Project Name: Madison County Schools - Madison Central Press Box Improvements

Project Number: 25-053

ADDENDUM NO. 01

MEN'S RESTROOM FOUNDATION PLAN

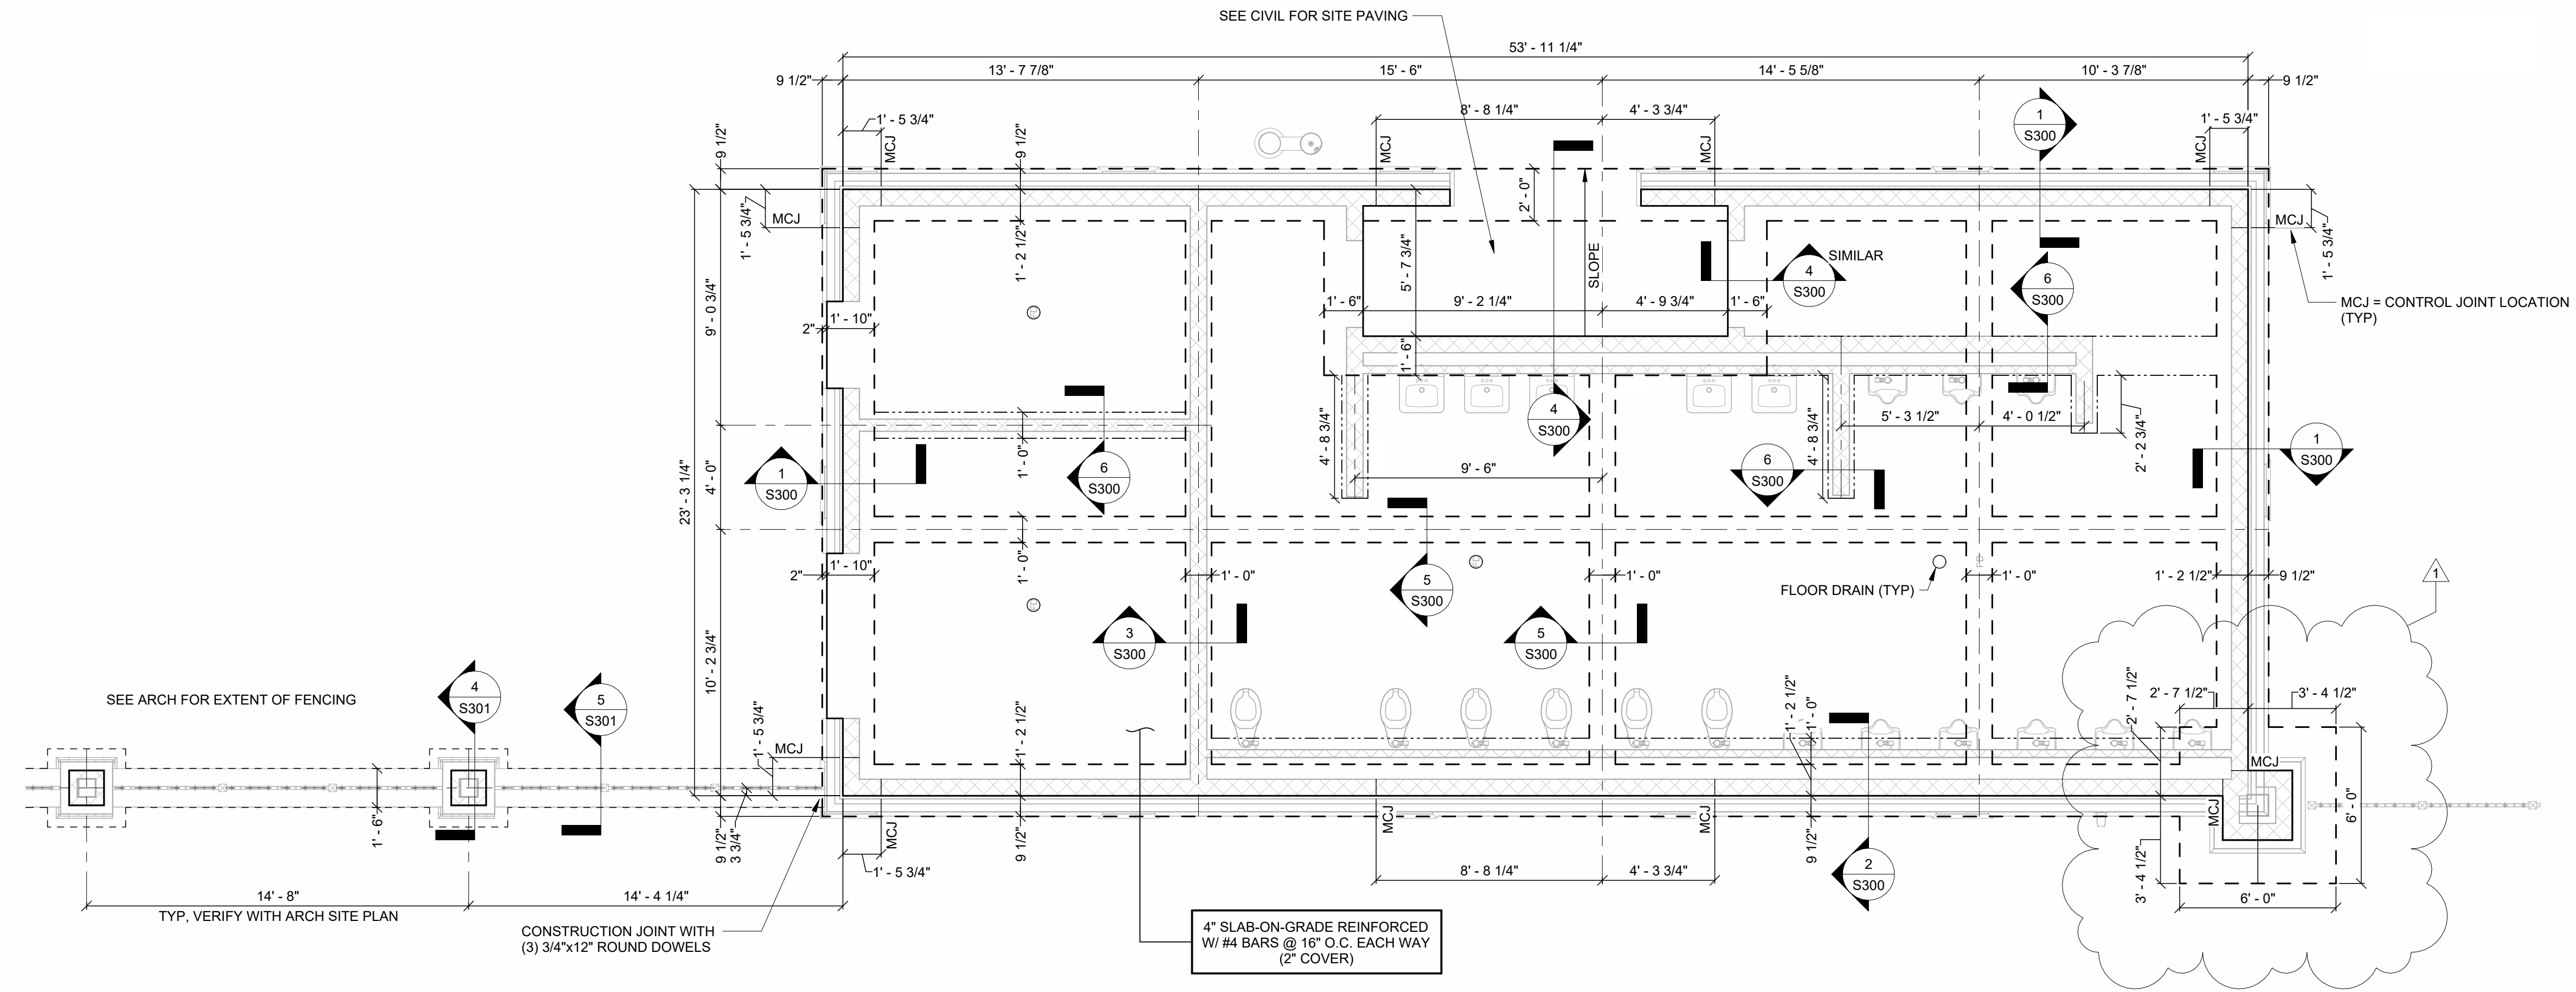
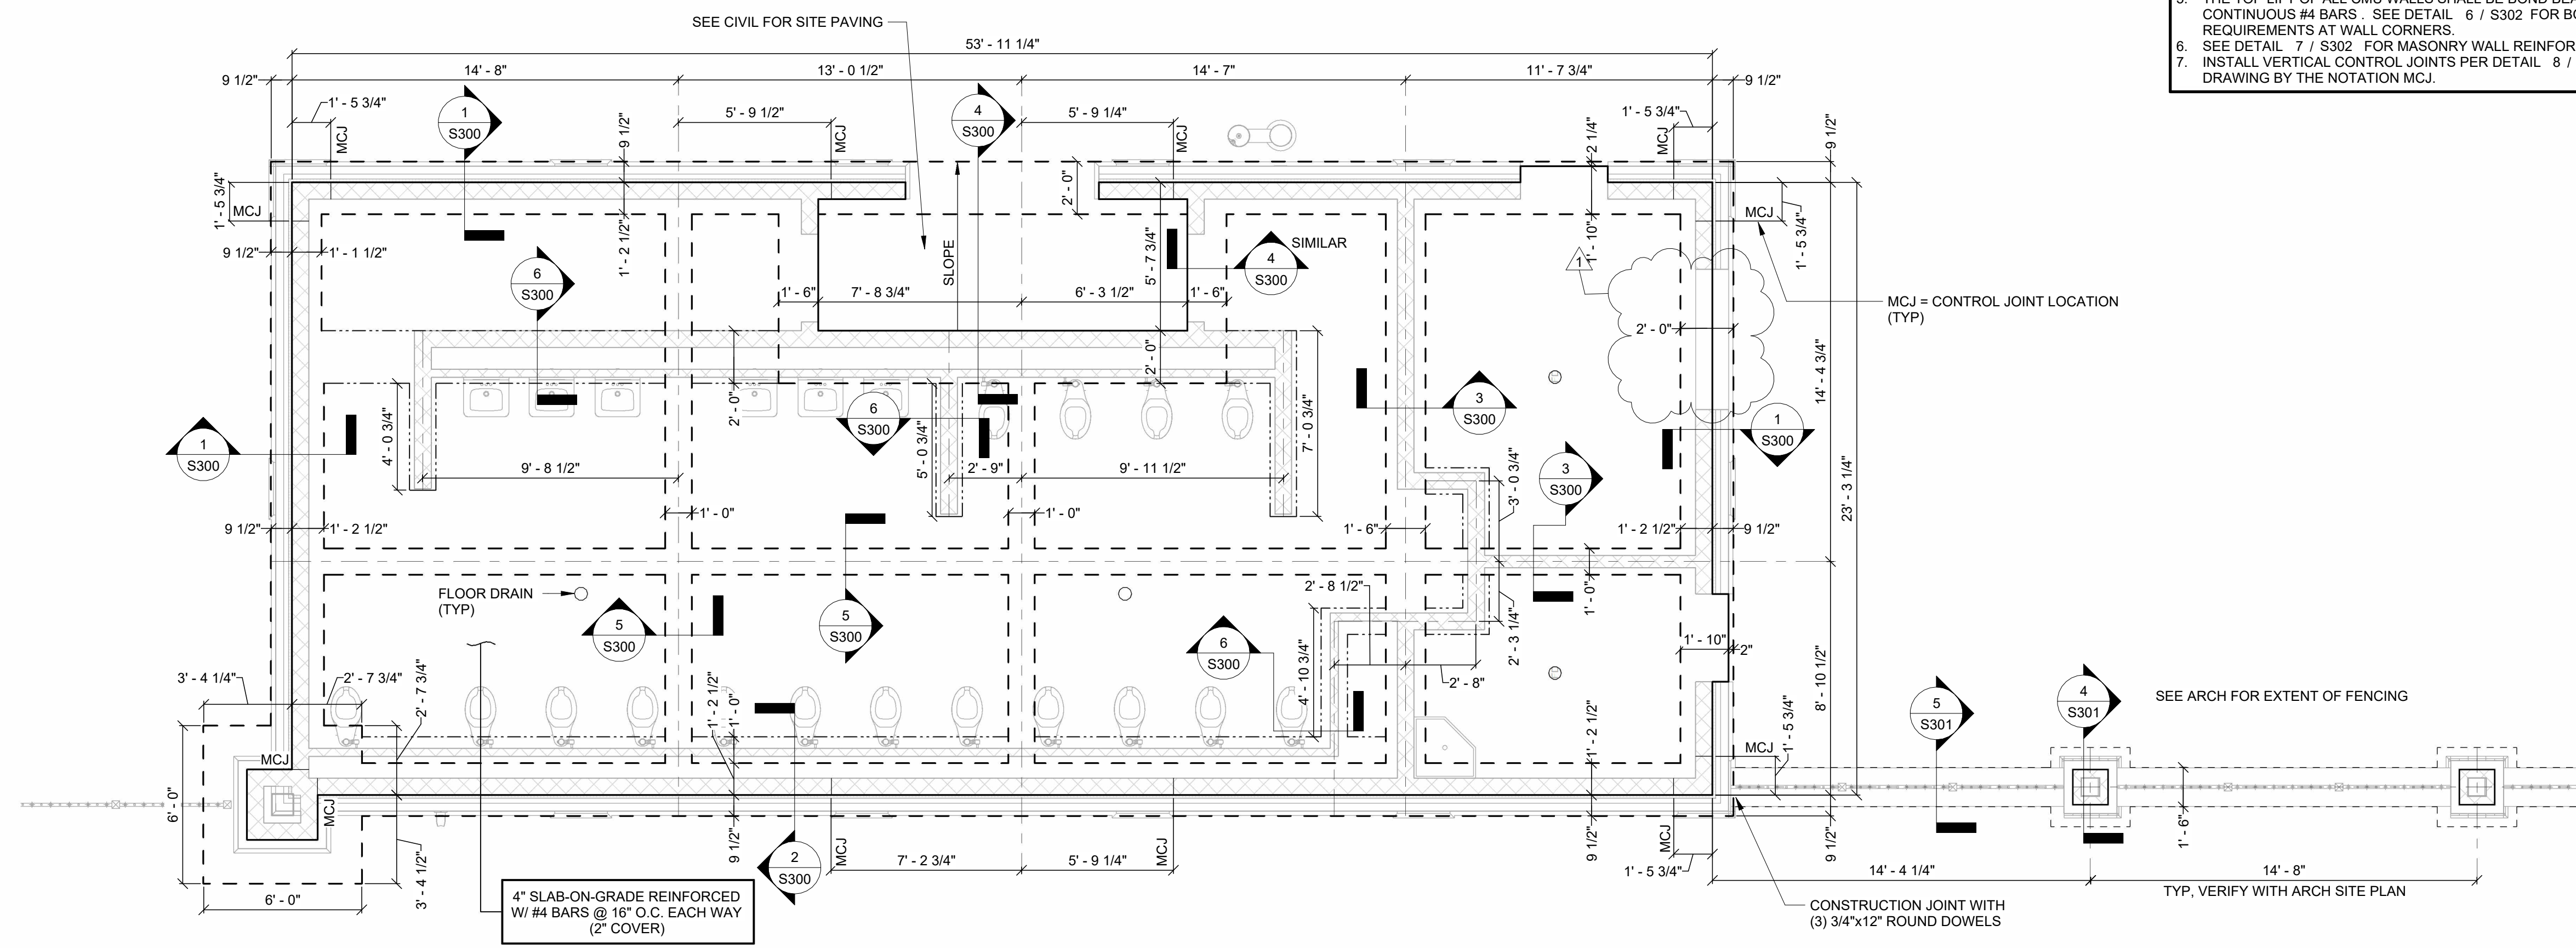
- ITEM NO. 26 **S201 RESTROOM FOUNDATION PLAN**
REVISE foundation dimensions as shown.
- ITEM NO. 27 **S302 DETAILS**
REVISE parapet details 1/A302 and 2/A302 to anchor cast stone as shown.

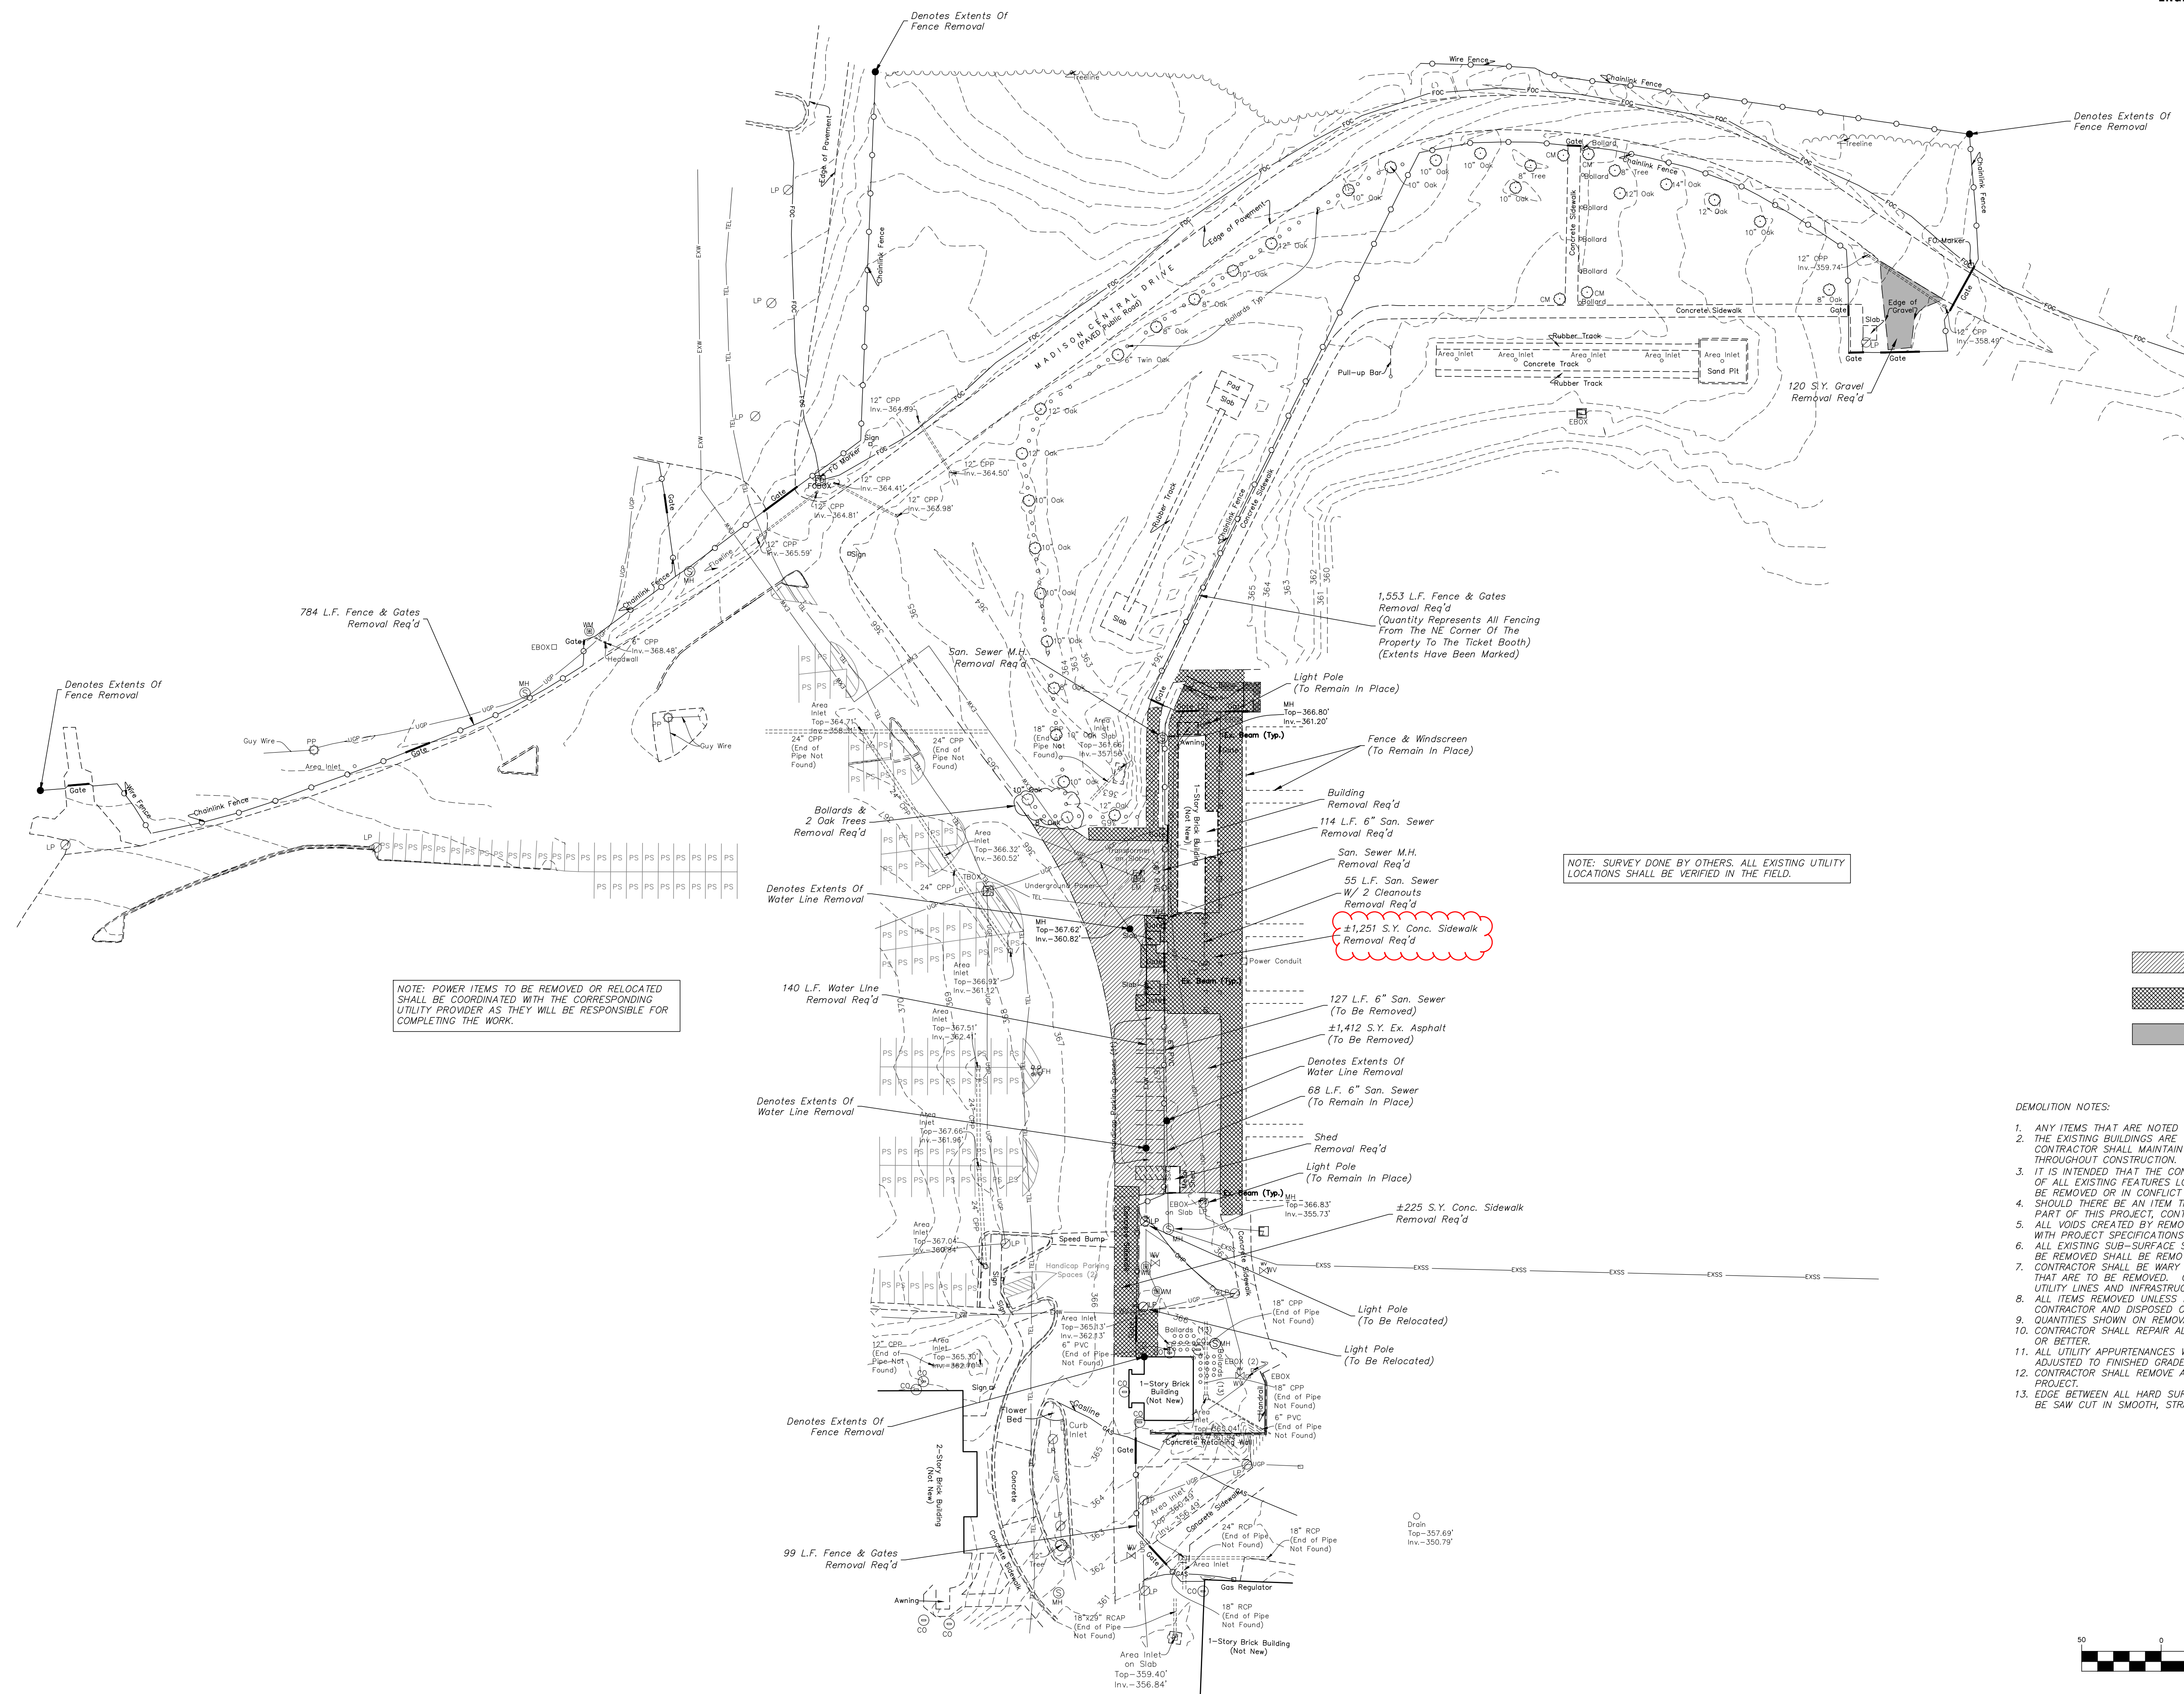
- ITEM NO. 13 **C200 DEMOLITION PLAN**
REVISION: Updated the extents of existing concrete removal.
- ITEM NO. 14 **C201 SITE PLAN**
CLARIFICATION on length of curb and ADA reamp reference.
